**ADDENDUM 1**  
**Sausalito Library Renovation Project**  
**420 Litho St.**  
**Sausalito, CA 94965**  
**August 23, 2012**

**THE FOLLOWING ITEMS REPRESENT Addendum NO. 1**

The purpose of this addendum to the current Bid package for the above-referenced project is to provide clarifications, additions, deletions, changes, and / or revisions to the package per the attached documents and sheets.

**A2.0**  
 08-22-2012

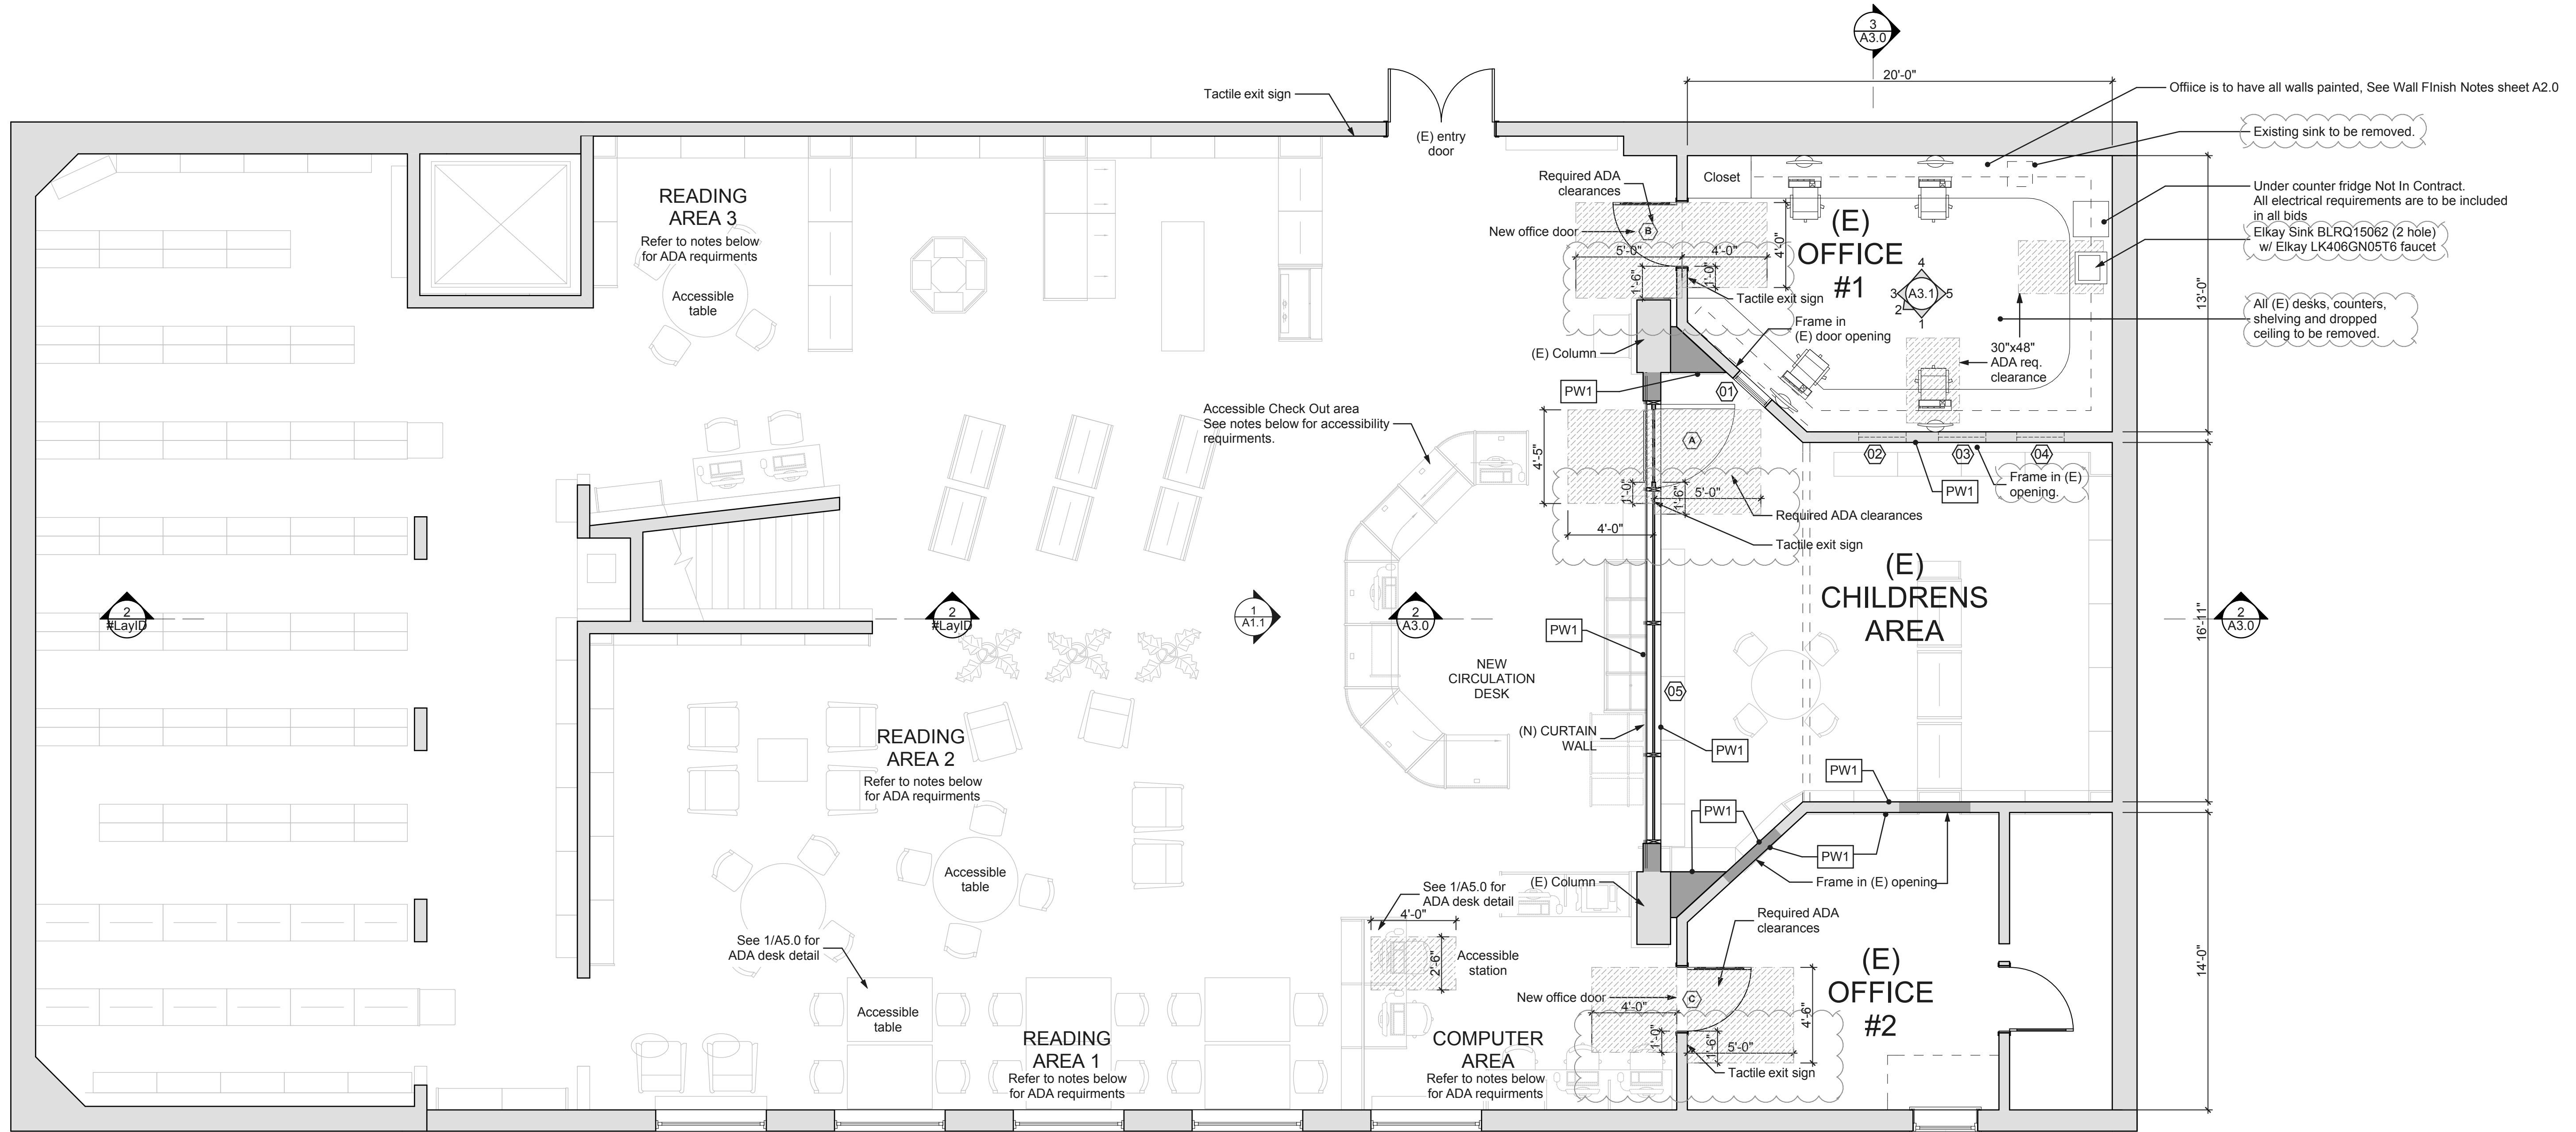
- 1) Revised Contract Drawings are attached. Changes have been clouded.
- 2) Sheet A2.0 – Scope Added – Contractor shall include demolition and removal of all built in cabinetry and casework in Office (Staff Office). All contents of cabinets will be removed by DPW. All remaining cabinetry and casework shall be demolished and removed by Contractor.

- 3) Sheet A2.0 – Scope Clarification – At Reading Area 2 and Computer Area, Accessible Station and Accessible Tables are not responsibility of Contractor.

- 4) Sheet A2.0 – Scope Clarification – Installation of Rough Plumbing. If top of page is North, then currently existing on the north wall of the Staff Office is a sink with hot and cold water supply. The rough plumbing will be relocated from the north wall to the East Wall.

- 5) Sheet A2.0 – Change of Scope – In Staff Room, Contractor Shall include in Bid Price New Sink and Fixtures per Specification added to this addendum.

- 6) Sheet A2.0 – Change of Scope – Door and Hardware schedule has been updated to include hardware specification.
- 7) Sheet A3.0 – Storefront – Storefront system shall be Anodized Bronze finish.

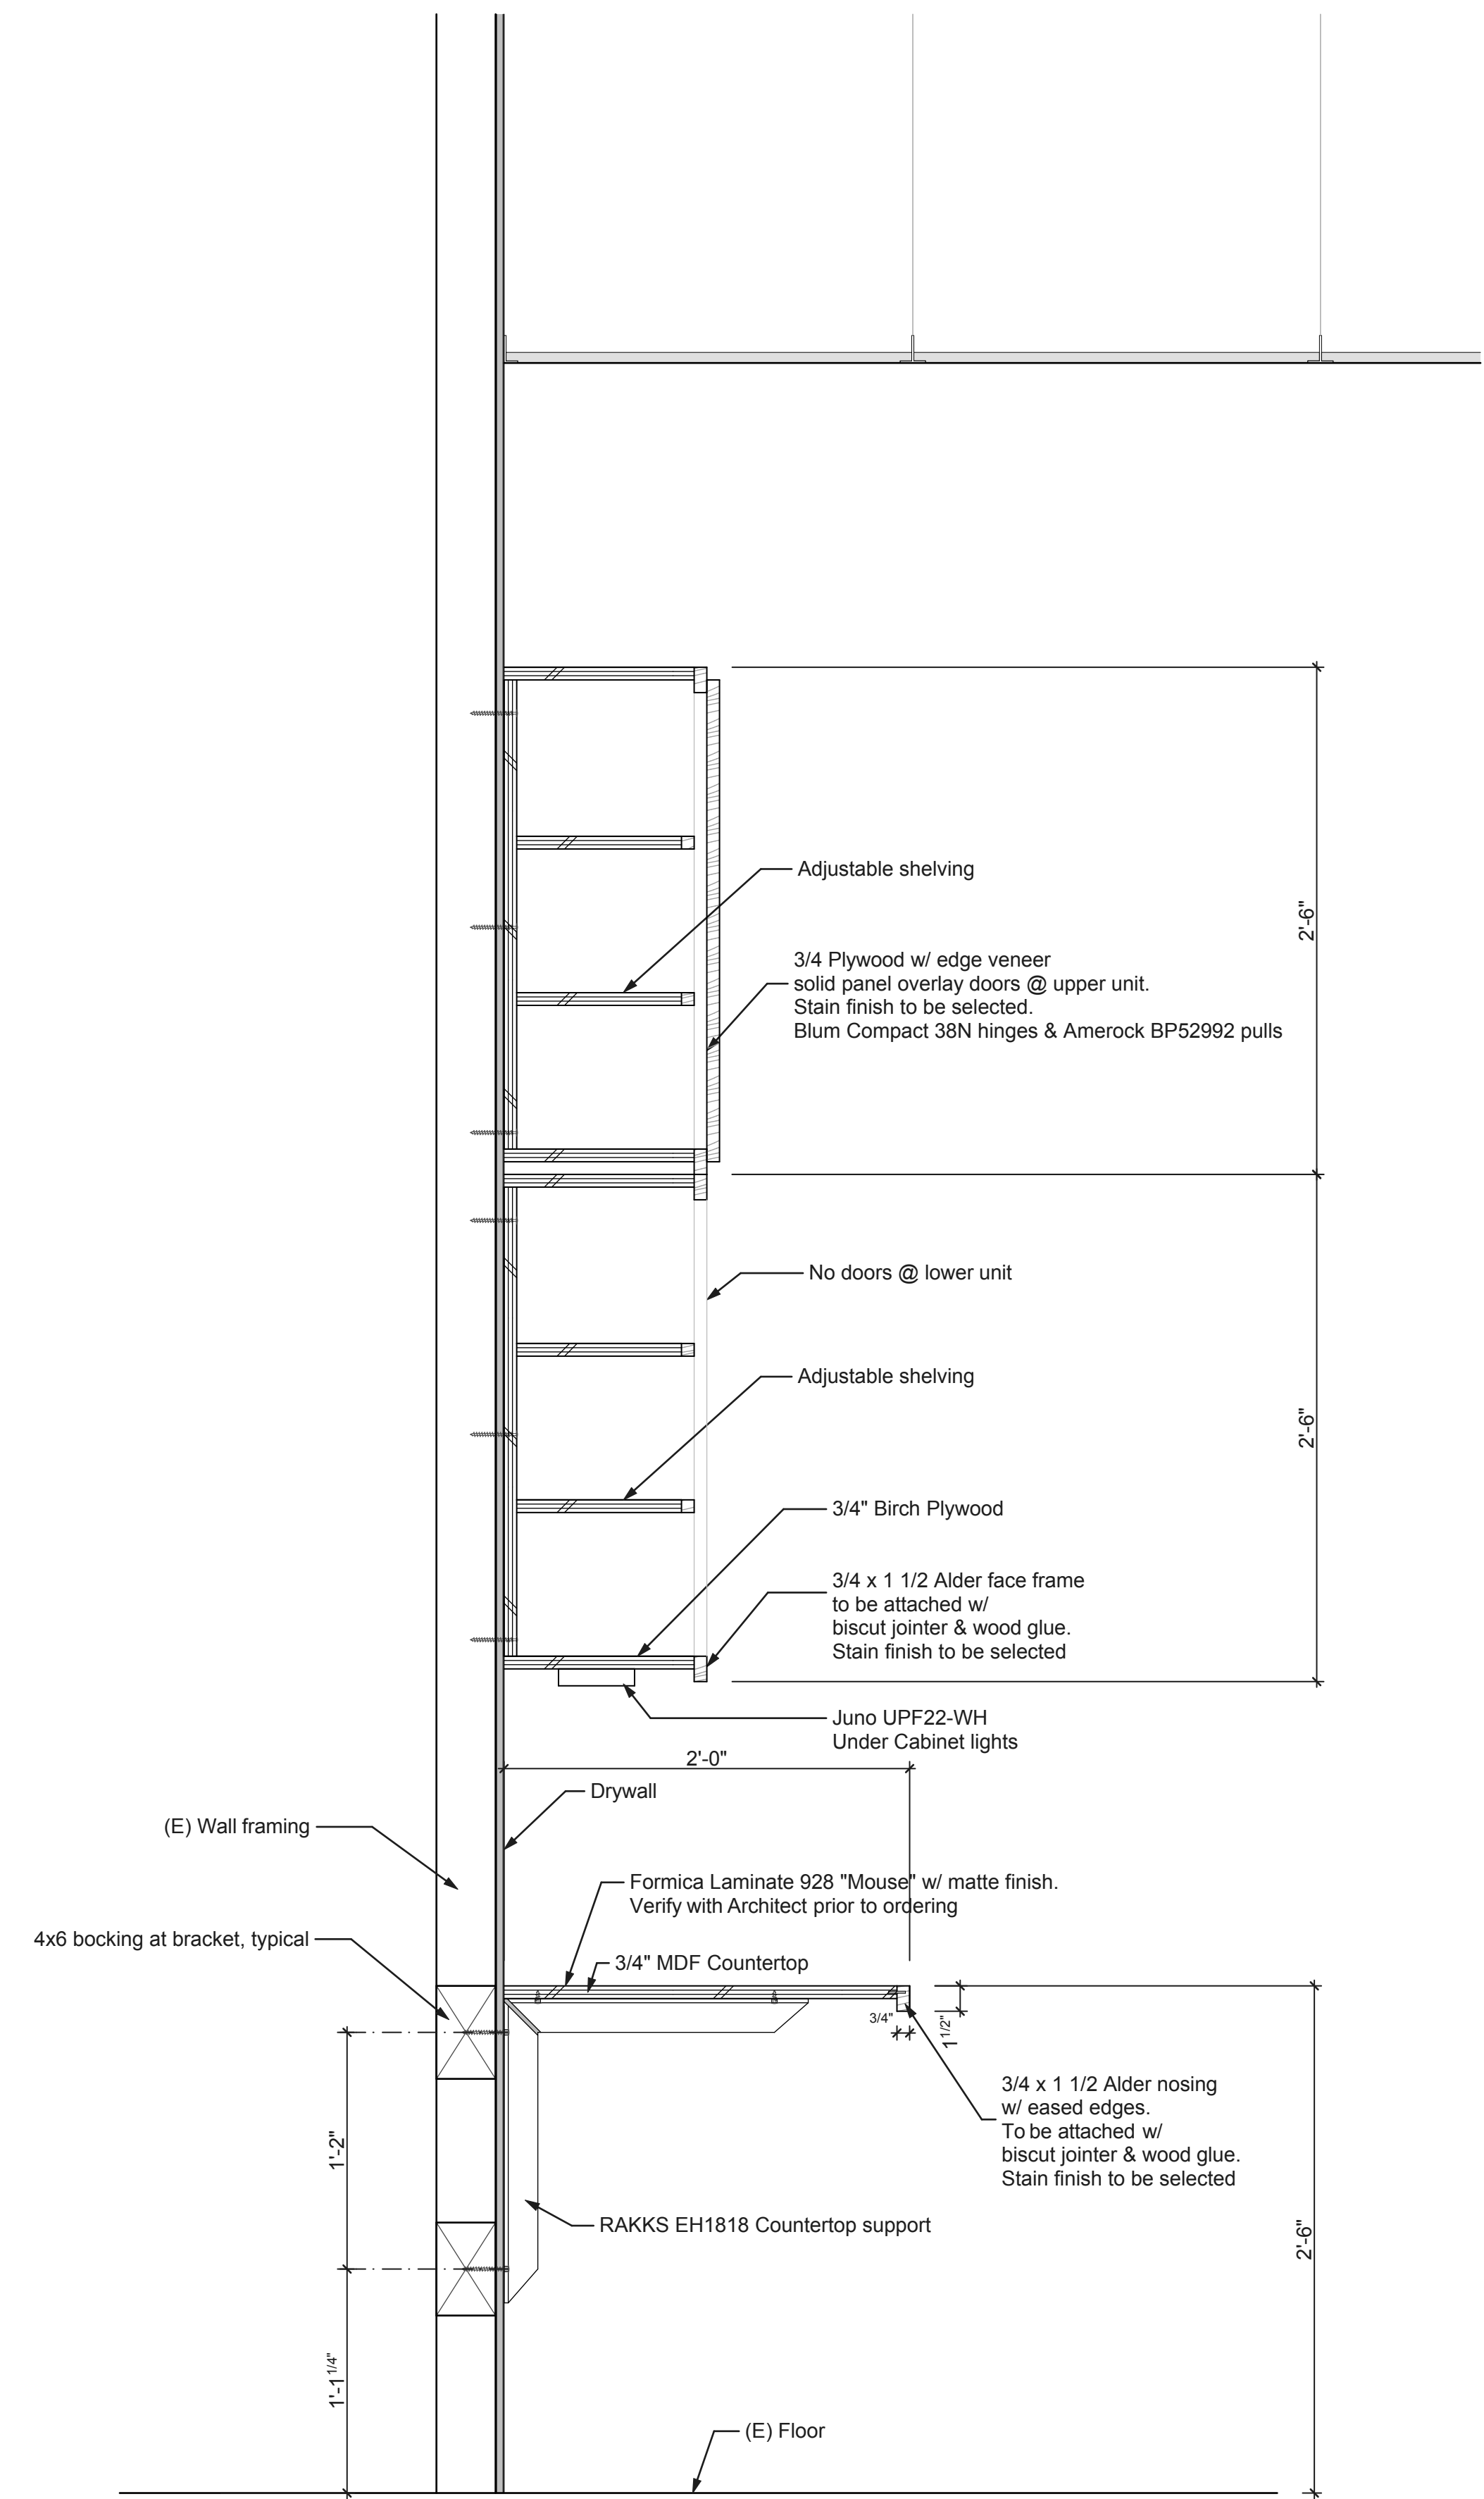
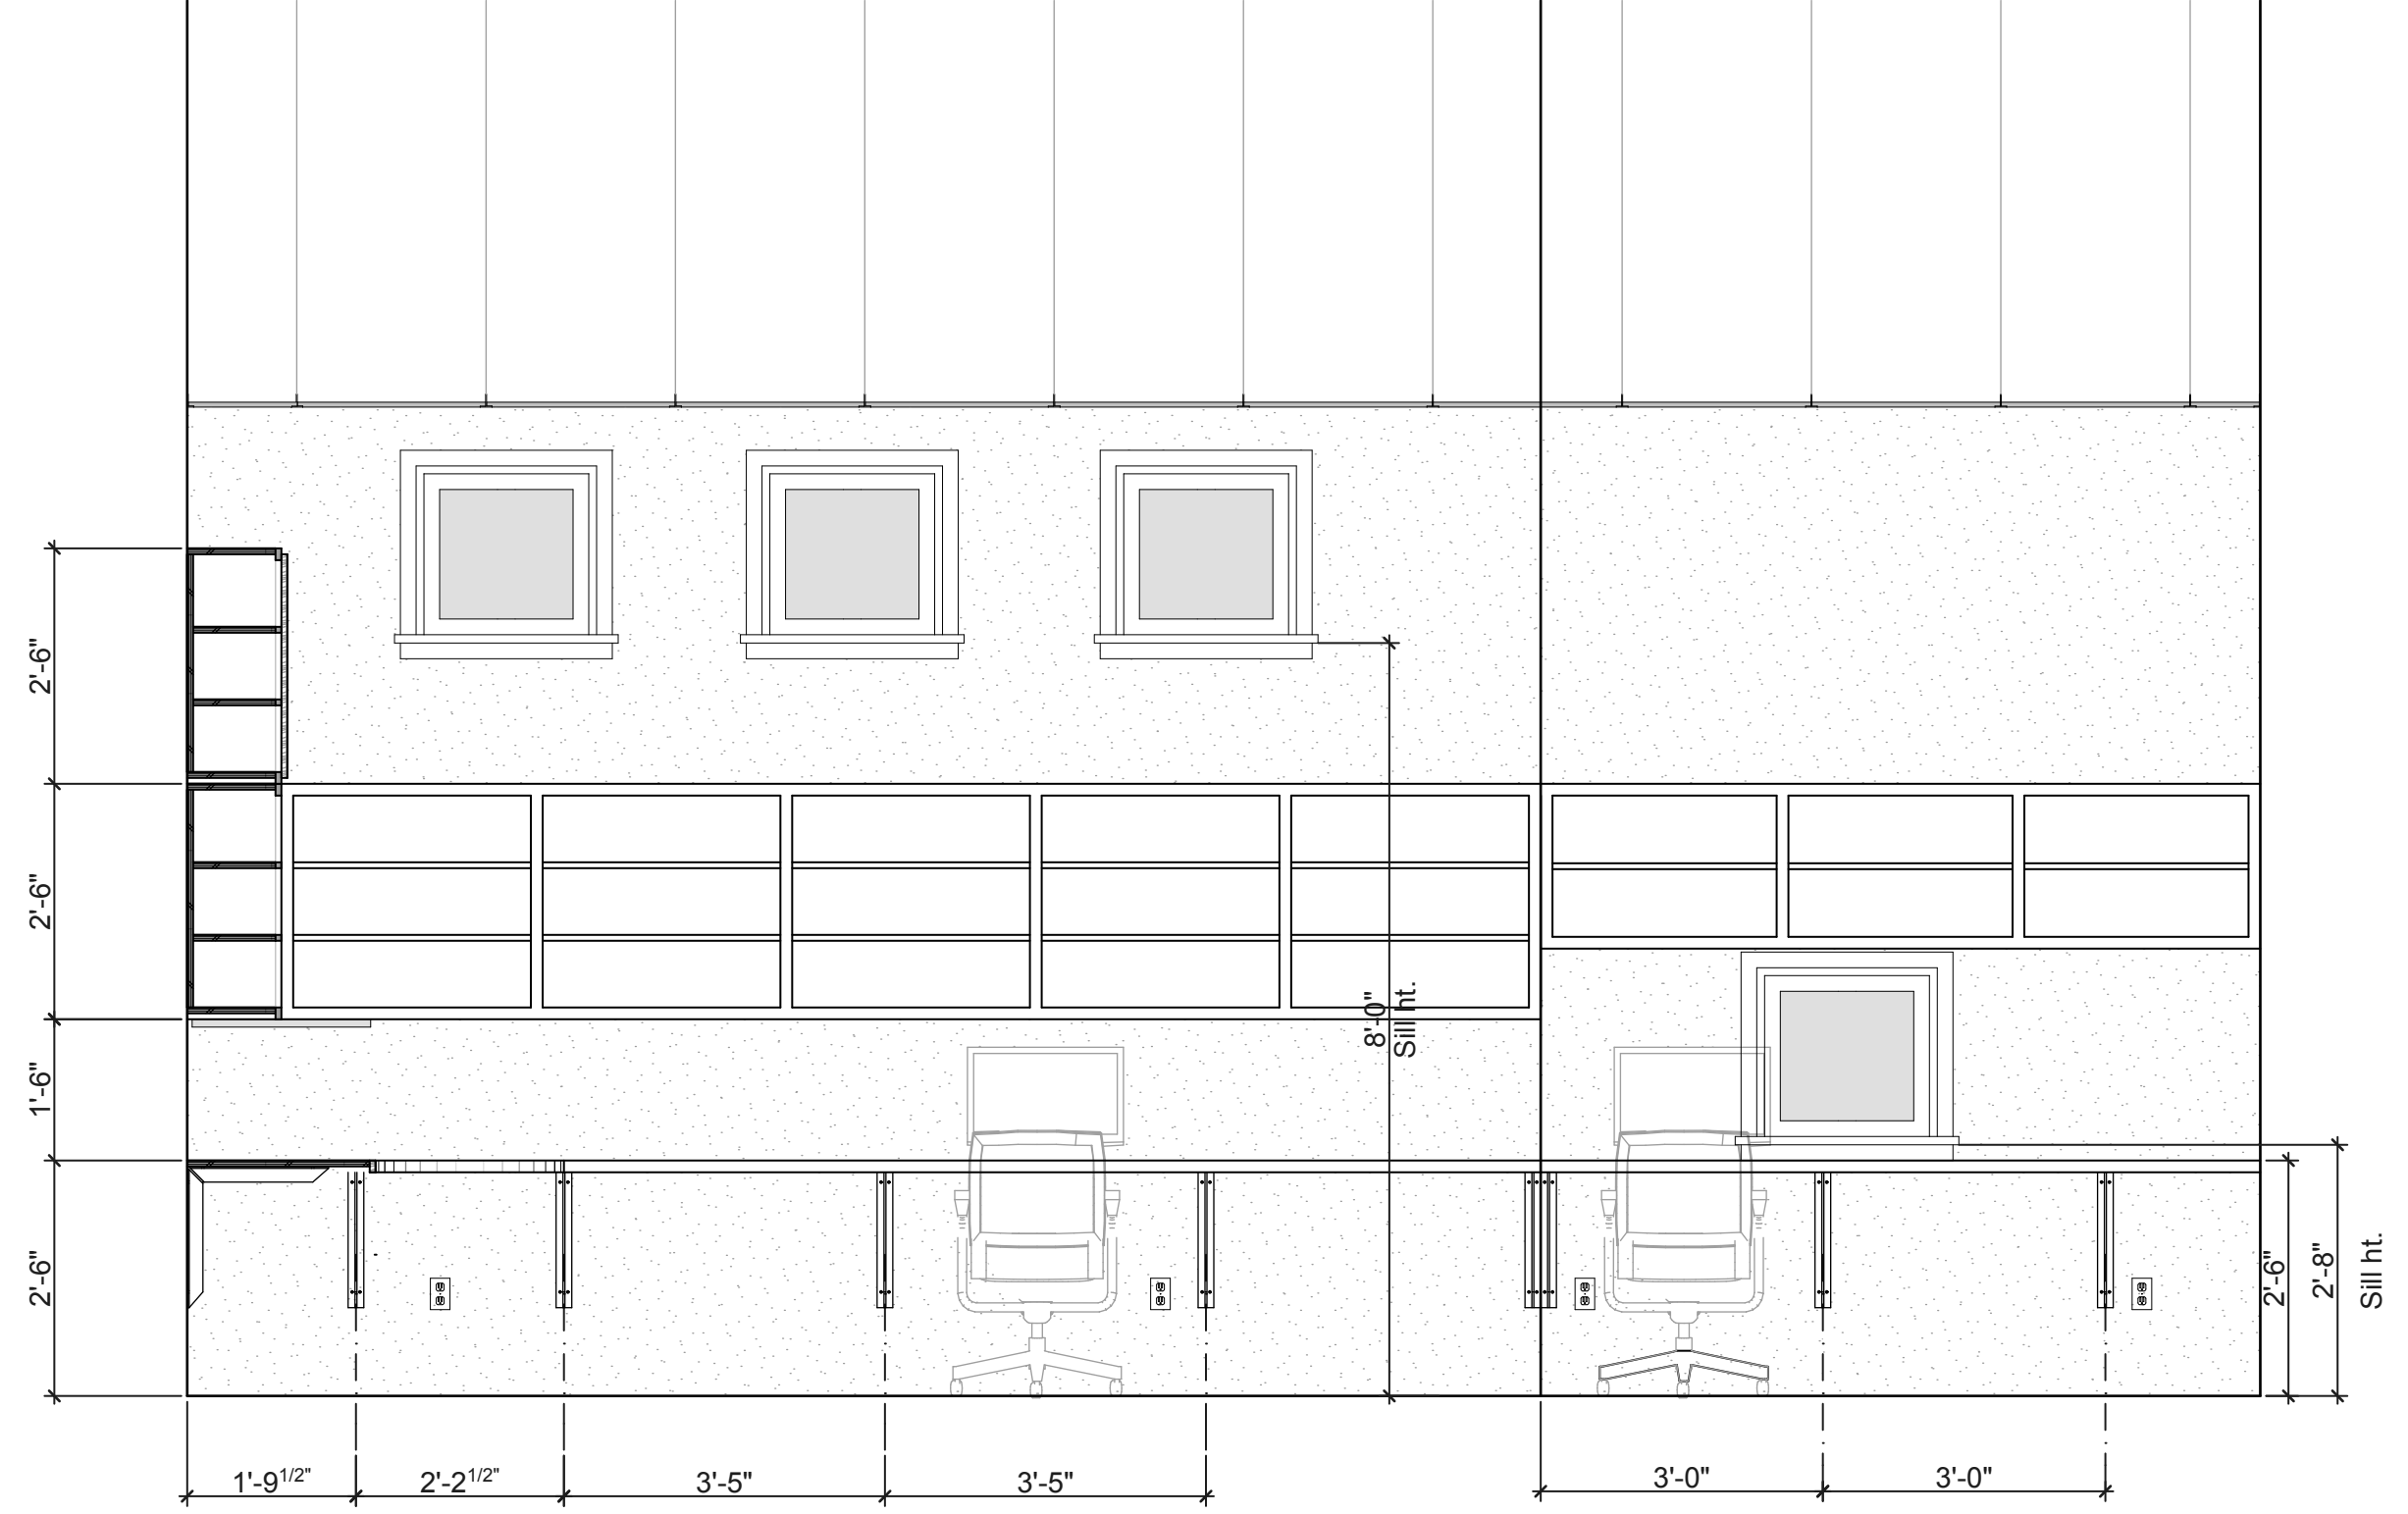
- 8) Sheet A3.1 – Change to Scope – Sheet A3.1 has been added to Contractors Scope of Work. Contractor shall include in Bid Price cost to install Casework in Staff Office.
